Model : GP605 Series**Ref. No. : FF-T01- K1-000037-01****Date : January 11, 2000**© Canon (UK) Limited

Location : ADF REVERSE FLAPPER**Subject : ADF REVERSE FLAPPER STUCK OPEN COUNTERMEASURE ADF****Reason :** After a document jam has been cleared, if the reverse flapper is touched, it may remain open. A countermeasure to this problem was implemented (FF-T01-K1-000011-03), but even with this modification, excess strength may cause the same problem to occur, so a further countermeasure has been implemented.**Details :** <Symptom>

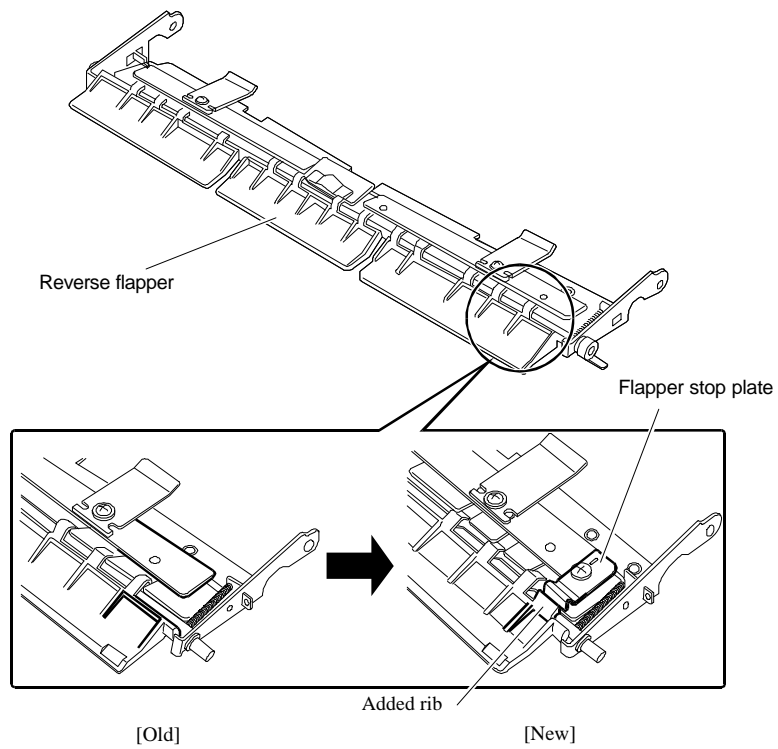
1. When attempting to clear a document jam, pressure is applied by hand to open the lower flapper in the lower section of the ADF, the flapper may get stuck in the open position. A countermeasure was implemented, but it was discovered that, even with this modification, the application of undue force would cause the same problem.
2. Further, in pre-reverse paper pickup, the link piece that makes the reverse flapper rotate has very little margin for error in between the parts dimensions and variations in the assembly accuracy, so that sometimes it may not be in the specified position. Therefore, the reverse flapper is controlled so that it drops downward, and there is a possibility that that it may touch the copyboard glass, resulting in a bent corner.

1. The flapper remains stuck in the open position because the physical force used to clear jams in the field may be greater than anticipated by Design. Also, with the previous countermeasure part, once the reverse flapper is opened, the lower guide plate, which is in contact with the reverse flapper, gets bent out of shape, and is prone to open.
2. The cause of the bent corner is the lack of margin for error in the part dimensions.

1. A reinforcing rib will be added to the reverse flapper, and a flapper stopper added to the lower guide, in order to strengthen the flapper rotation.

2. In order to increase the margin, the tolerance and shape of the following three parts will be modified.

FB4-7628, FB4-7656, FB4-7658

Servicing : If the flapper stuck open problem occurs, replace the whole unit.
Also, if document corners are getting bent, replace the three links simultaneously.
